Design Review Revisions

Child Street Open Space

Reference: Child Street Open Space – Design Revisions and Temporary Power Station
PB #179
Cambridge Crossing
Cambridge, Massachusetts

Reference: Parcel U Design Review Revision – View Glass
PB #179
Cambridge Crossing
Cambridge, Massachusetts

— Locations where View Glass is visible

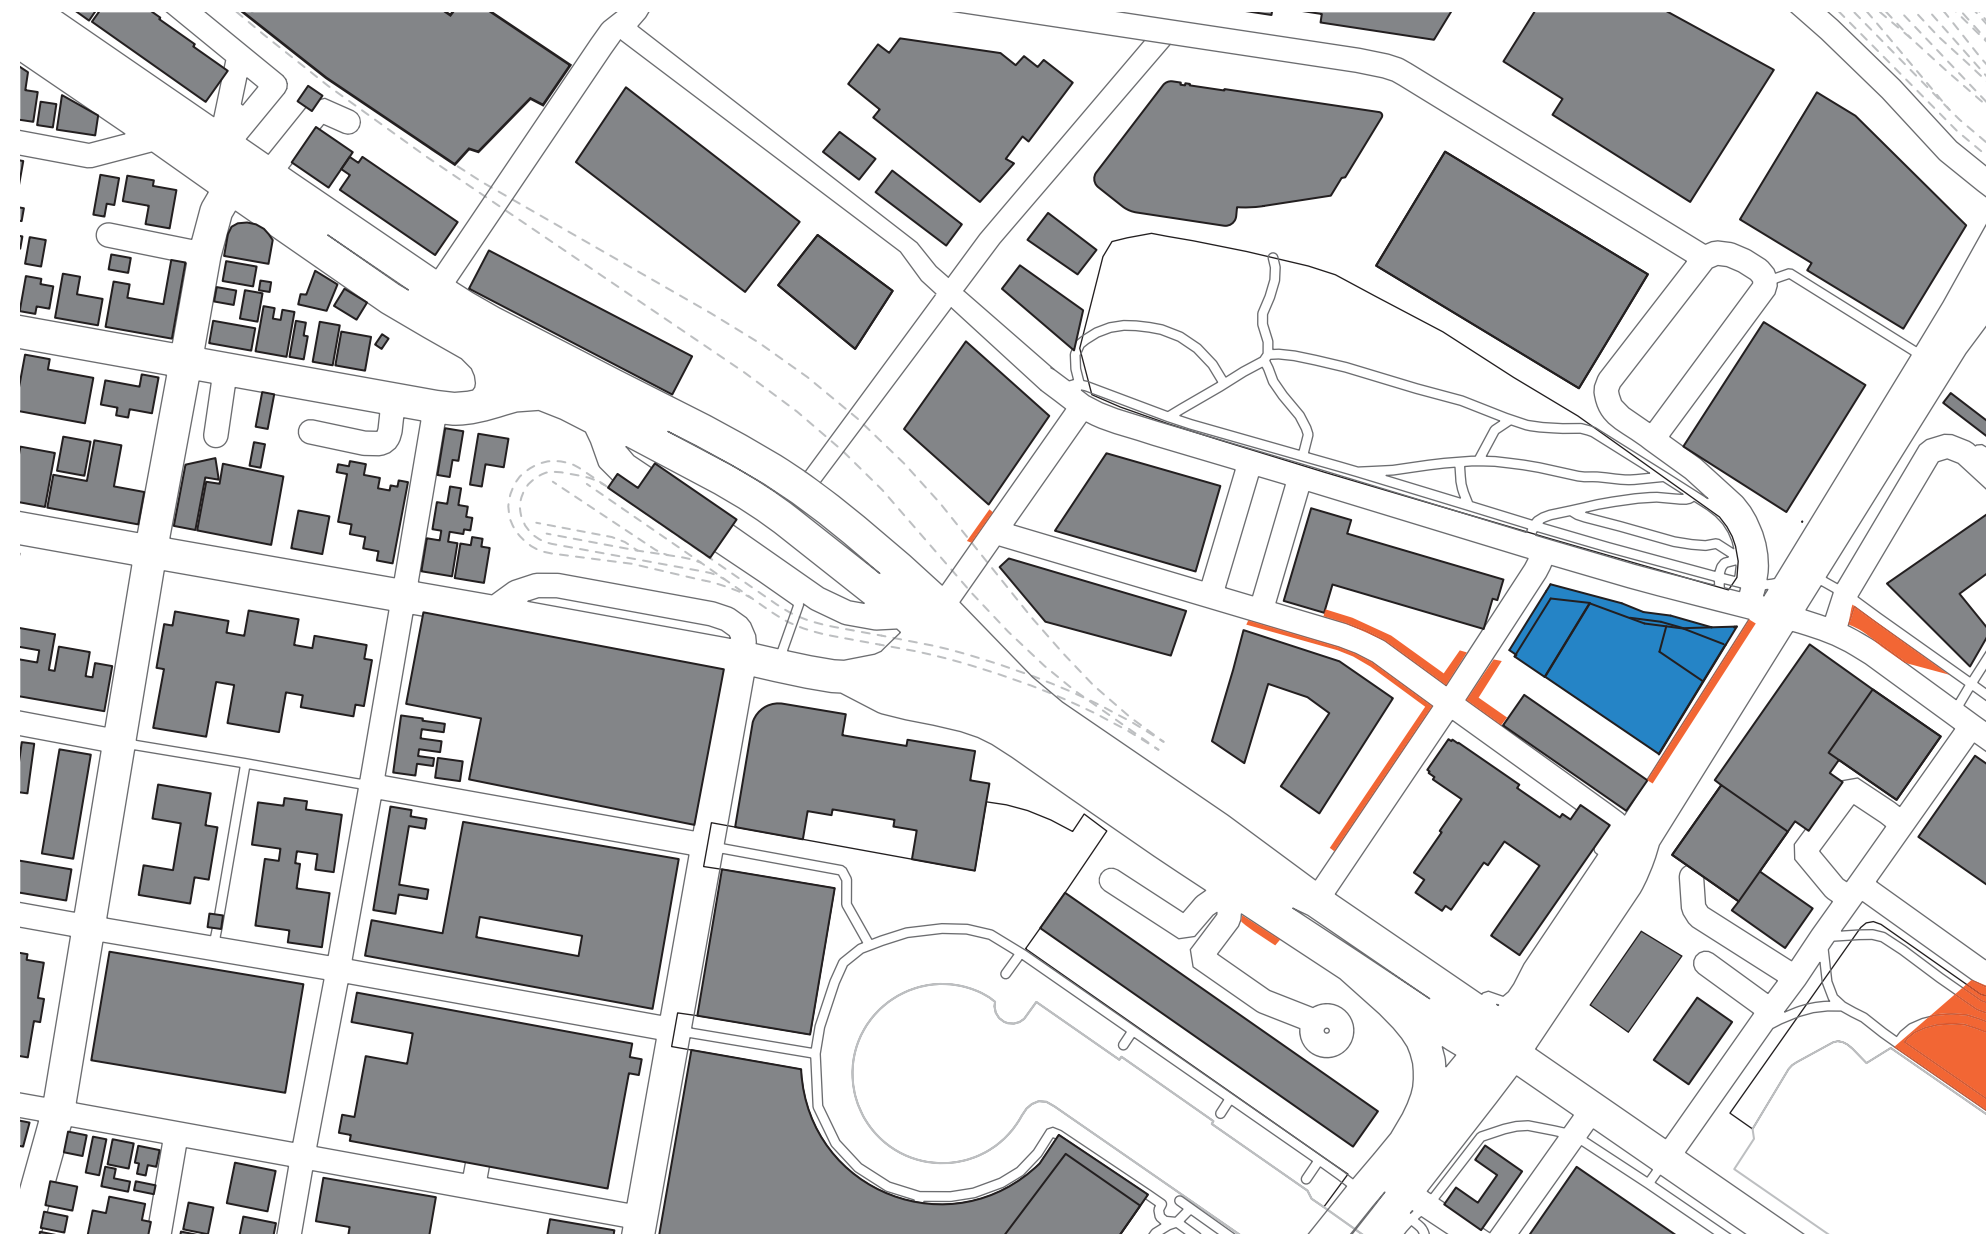
As we have advanced the design of the Project, we are considering the inclusion of smart windows manufactured by View, Inc. (“View Glass”) on the southeasterly and southwesterly façades of the Project, those with solar exposure. These areas are more particularly shown on the attached renderings and elevations.

Second, at Parcel U, the glass in the northwestern façade, facing Leighton Street and the Common, and the northeastern façade, facing Morgan Avenue and the Common, would remain as approved by the Planning Board. DivcoWest is proposing to be allowed to use View Glass on the two facades, southwestern and southeastern, that have solar exposure. These two façades do not face city streets or open space, so any reduction in transparency in these facades will have a correspondingly reduced impact on the public realm.
